RE: C.G.S. 8-24 Referral – Planning & Zoning
Sewer Main Extension – 19 Cannon Rd

**GENERAL STATUTES § 7-246a APPLICATION OF
BAYWING L.L.C. FOR SEWER EXTENSION,
ALLOCATION OF
SEWER CAPACITY, AND APPROVAL TO CONNECT A
MULTI-FAMILY DEVELOPMENT
AT 19 CANNON ROAD, WILTON**

Re: Application of Baywing L.L.C. for Approval to Sewer Extension, Capacity Allocation, and Sewer Connection, 19 Cannon Road, Wilton

C4.4

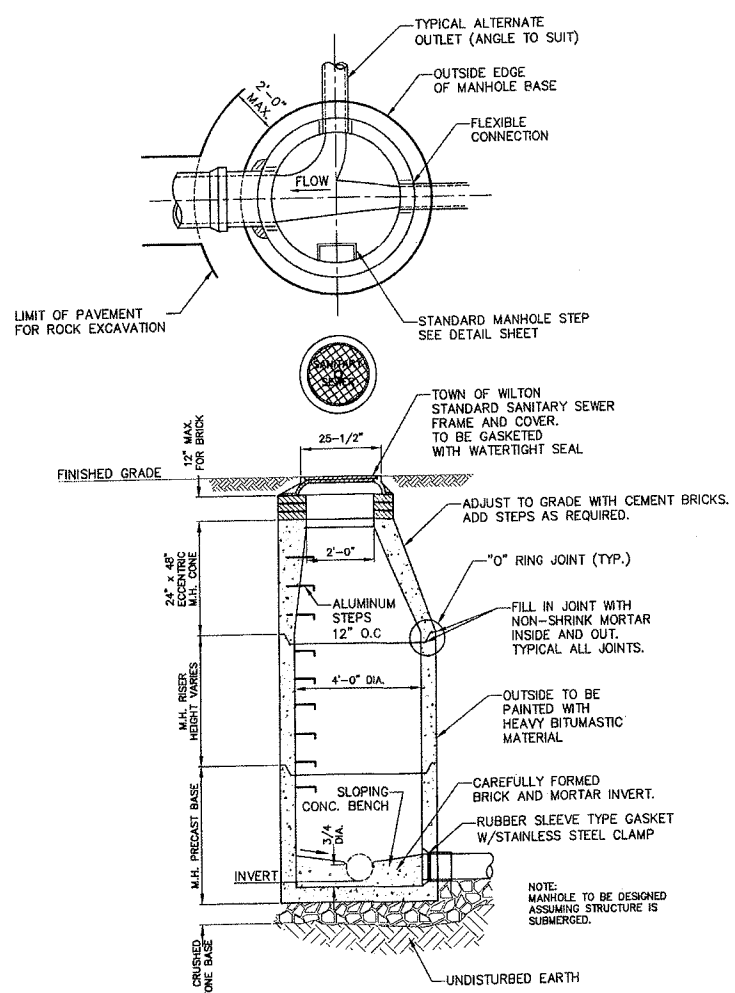
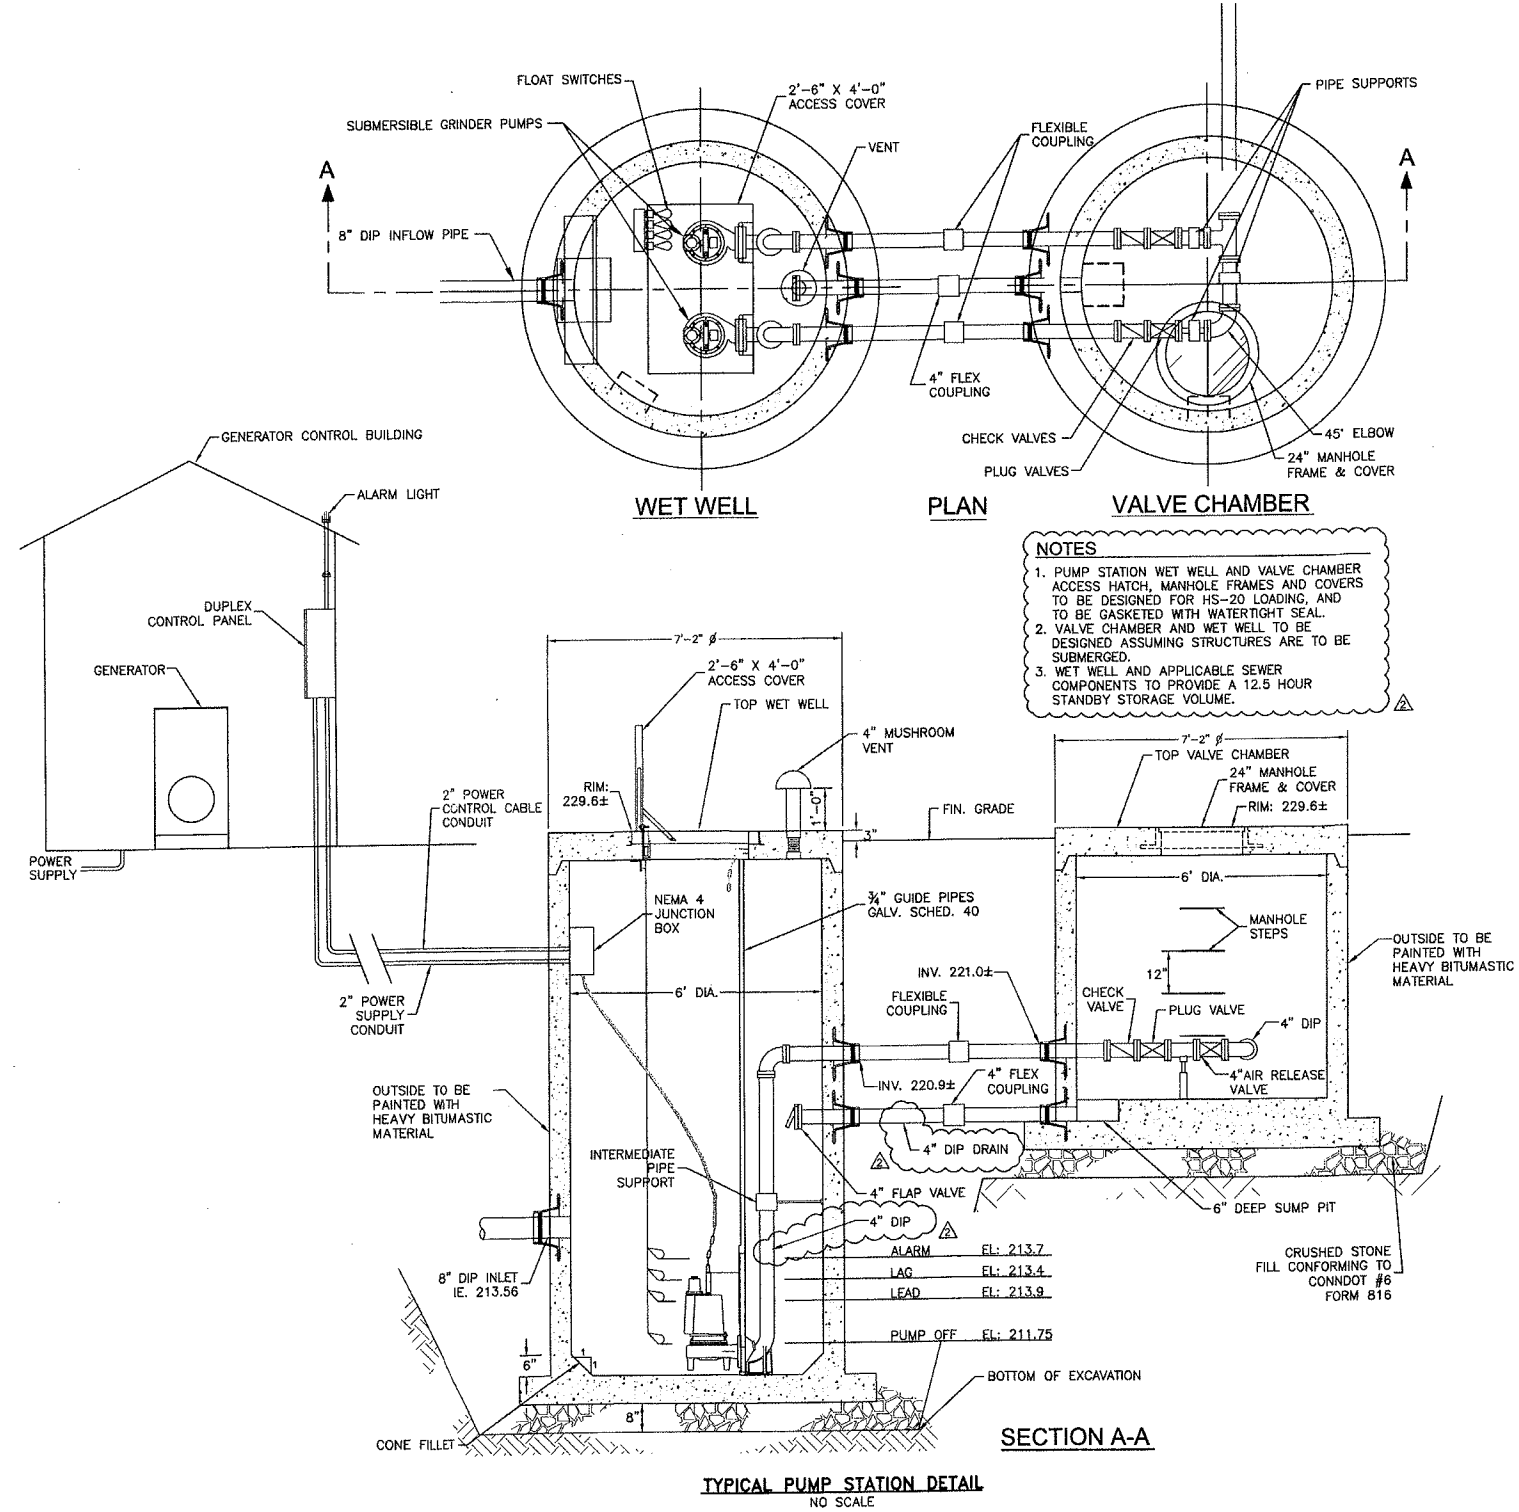
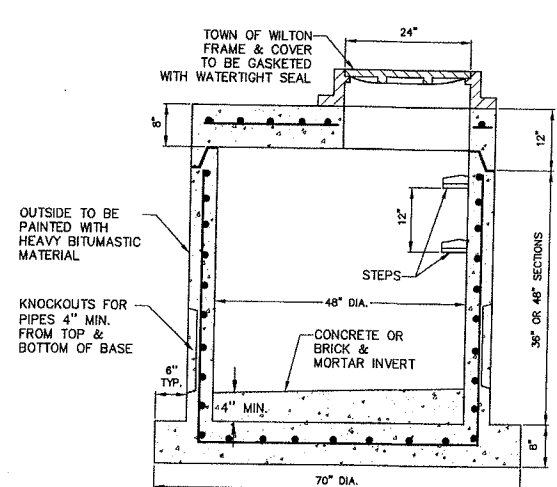
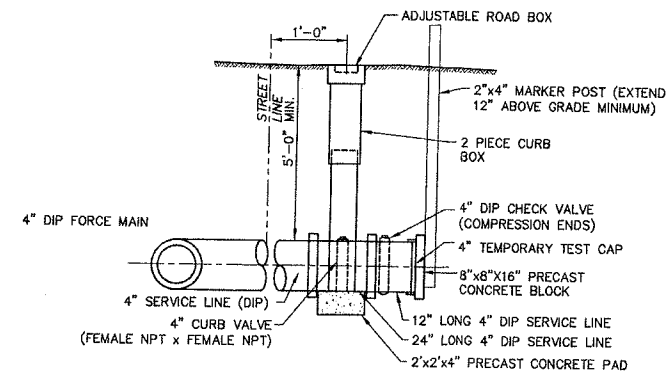
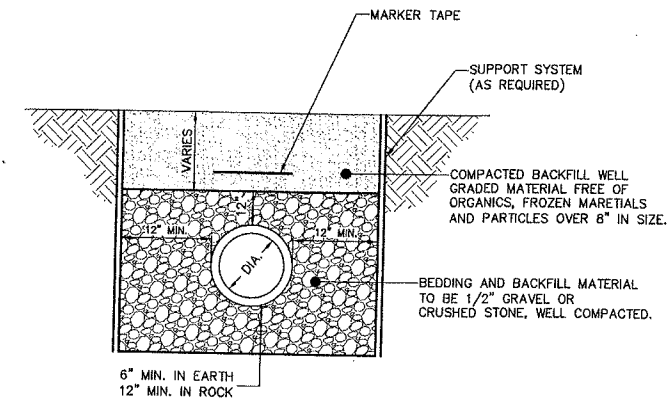
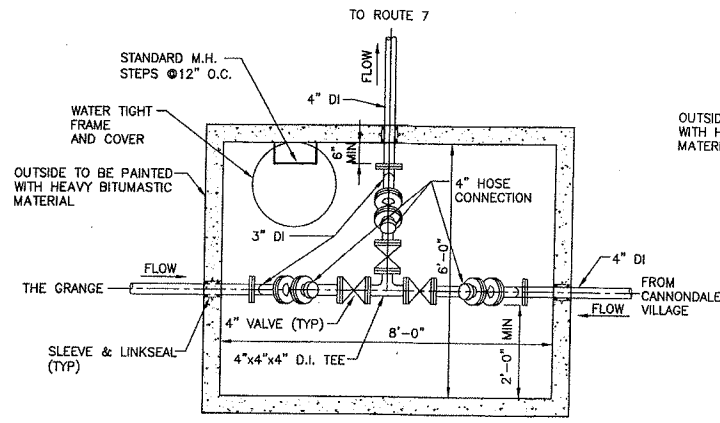
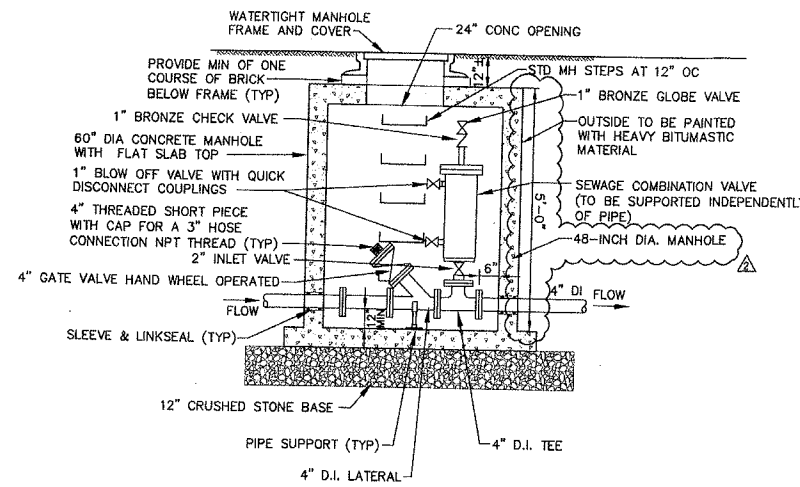
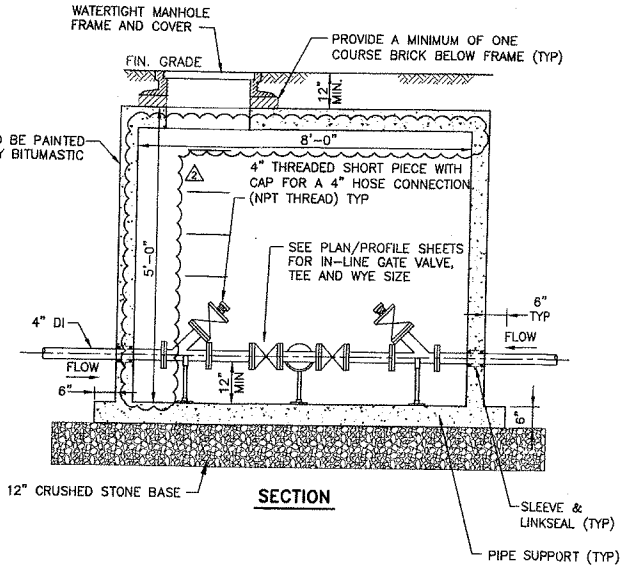
3. *Revise Plans to show watertight manhole covers and hatches.*

4. *Revise plans to show waterproof wet well structures and connections.*

4. *Please identify discharge pipe size and material inside the wet well on drawing number C-4.4.*

5. *Add overall dimensions to junction cleanout and air release structure details on drawing number C-4.5.*

RESPONSE: We have revised the detail sheet to incorporate this comment.

RESPONSE: We have revised the detail sheet to incorporate this comment.

RESPONSE: We have revised the detail sheet to incorporate this comment.

RESPONSE: We have revised the detail sheet to incorporate this comment.
